Access Compliance Report

Public Rights-of-Way

Intersection ID: 6591	Main Street: PRAIRIE_VALLEY_DR	Cross Street: COCHRANE_DR	Location:	N
ADA ID: 6A8561DCD9CD	Ramp Type: PerpDiag	Initial Pass/Fail: Fail	Overall Compliance: No	Severity Score: 42.5
Codes/Mitigation Info/Possible Solution		Field Measurements/Component Compliance

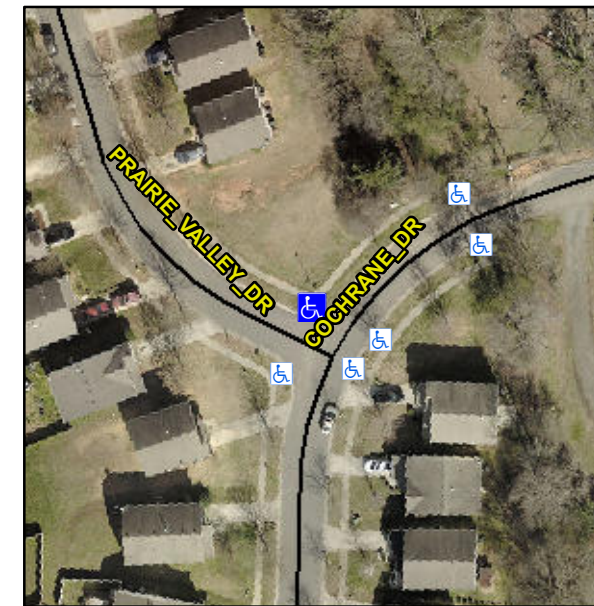
Not Found, R304.5.1, R304.5.3

Compliance	Description	Data	Compliance	Description	Data
N/A	Ramp Length (in)	84.5	Yes	Ramp Slope (%)	7.8
No	Ramp Width (in)	32.0	No	Ramp XSlope (%)	7.9
N/A	Flare Type LT	N/A	N/A	Flare Type RT	N/A
N/A	Flare Slope LT (%)	N/A	N/A	Flare Slope RT (%)	N/A
N/A	Flare Traversable LT?	N/A	N/A	Flare Traversable RT?	N/A
N/A	Landing Length (in)	N/A	N/A	DWS Provided?	N/A
N/A	Landing Width (in)	N/A	N/A	DWS Contrast?	N/A
N/A	Landing Slope (%)	N/A	N/A	DWS Length (in)	N/A
N/A	Landing X Slope (%)	N/A	N/A	DWS Full Width?	N/A
N/A	Landing Curb? (Y/N)	N/A	N/A	DWS Offset (in)	N/A
N/A	Shared Landing?	N/A			
N/A	Gutter Ponding?	N/A	N/A	Gutter Slope (%)	N/A
N/A	Gutter Lip Ht (in)	N/A	N/A	Gutter X Slope (%)	N/A
N/A	Painted X Walk1?	No	N/A	Painted X Walk2?	No
	X Walk 1 Direction	To SW		X Walk 2 Direction	To SE
N/A	X Walk 1 Width (in)	N/A	N/A	X Walk 2 Width (in)	N/A
	X Walk 1 Slope (%)	0.9		X Walk 2 Slope (%)	4.4
	X Walk 1 X Slope (%)	6.3		X Walk 2 X Slope (%)	5.7

N/A	Ramp inside XWalk1?	N/A	N/A	Ramp inside XWalk2?	N/A
	Road Slope (%)	7.1	N/A	Clear Space?	N/A
	Road X Slope (%)	2.0	N/A	Clear Space to XWalk (in)	N/A
N/A	Any Obstructions?	N/A	N/A	Storm Grate/Utility Hazard?	N/A
	Obstruction Type			Storm Grate/Utility Type	
		N/A			N/A
			Yes	Surface Condition? (G/P)	Good

Remove & Replace Curb Ramp With Two New Directional Ramps or Equivalent.
